**Service Information Letter**

**Doc No. LSI-008**

**SUBJECT: Service Information for Master Control Unit, Part Number MC01-XXXXX. Removal/Replacement of AC2101 Alternator Control Module**

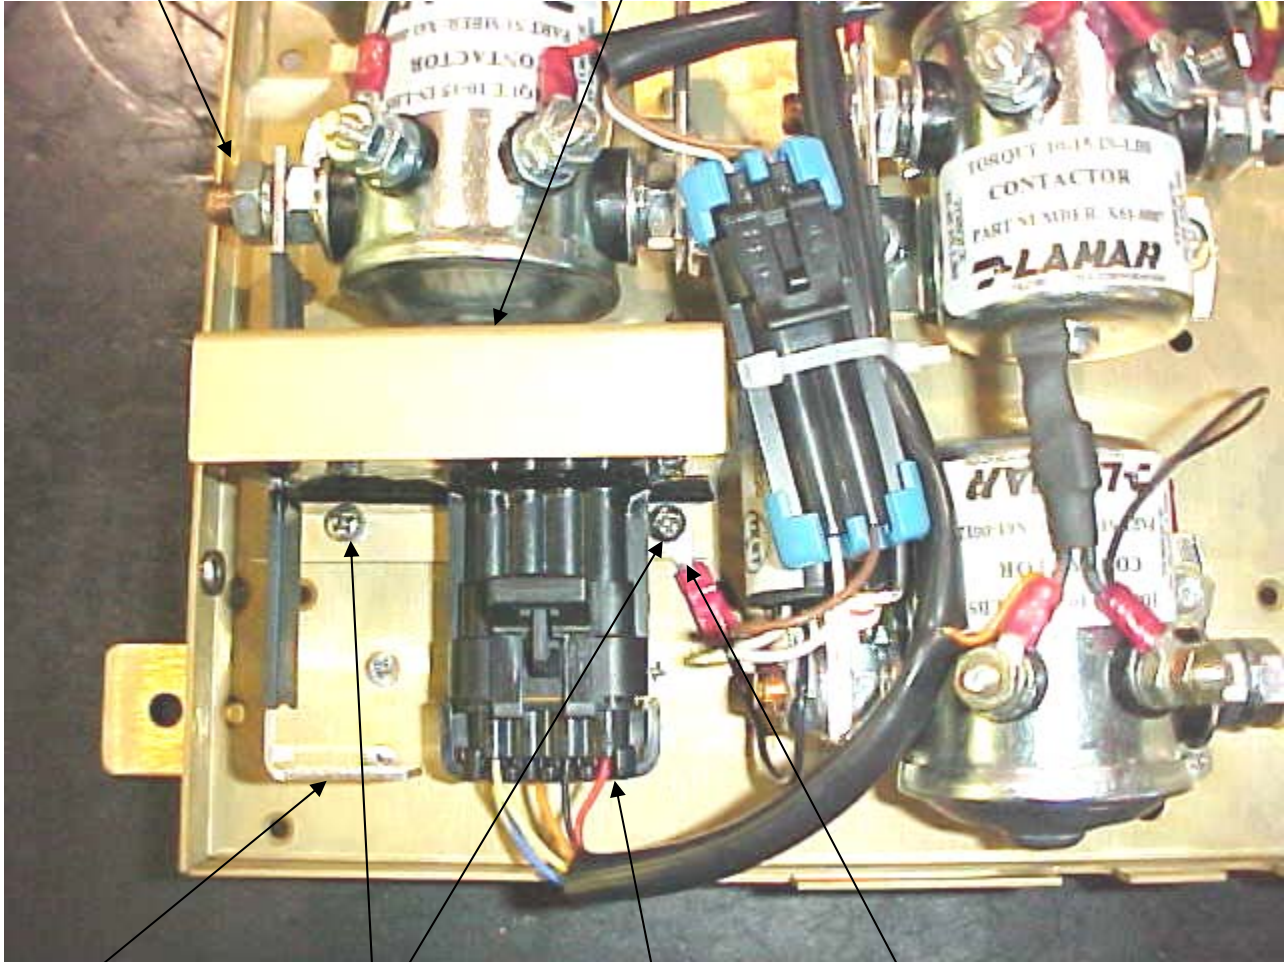
To prevent the occurrence of alternator field circuit breaker tripping during engine start.

- 1.) Remove cover from MCU.
- 2.) Inspect the label on the alternator control module (A). If the part number on the module is AC2101 and the serial number of the module falls between 195601 and 205400, it should be replaced with a new AC2101, revision I.C. 4 or above, per this procedure. If the part number is AC2100 or the serial number falls outside this range, no upgrade is necessary.

- 3.) If MCU is on aircraft, disconnect the alternator power cable from the AC2101 bus bar by removing the nut and bolt (B).
- 4.) Disconnect the cable plug from the AC2101 (C). The plug latch must be lifted to disengage.

- 5.) Remove the nut and washer securing the AC2101 bus bar to the alternator contactor (D).
- 6.) Loosen and remove the two screws securing the AC2101 to the base (E).

- 7.) Remove the AC2101 from the MCU
- 8.) Install new AC2101 (revision I.C. 4 or above) over the alternator contactor post and onto MCU base.
- 9.) Install two screws to secure AC2101 to base (E). Assure that ground wire lug is under one screw (F). Tighten screws to 12 in-lb.

- 10.) Install nut and lock washer securing AC2101 bus bar to alternator contactor (D). Tighten nut to 35 – 45 in-lb.
- 11.) Reconnect the cable plug to the AC2101 connector (C). Assure plug is fully seated by observing latch engagement.

- 12.) If MCU is on aircraft, reconnect the alternator power cable to the AC2101 bus bar (B) with nut, bolt and washer. Tighten nut to 35-45 in-lb.
- 13.) Replace the cover on the MCU and secure in place with the screws.
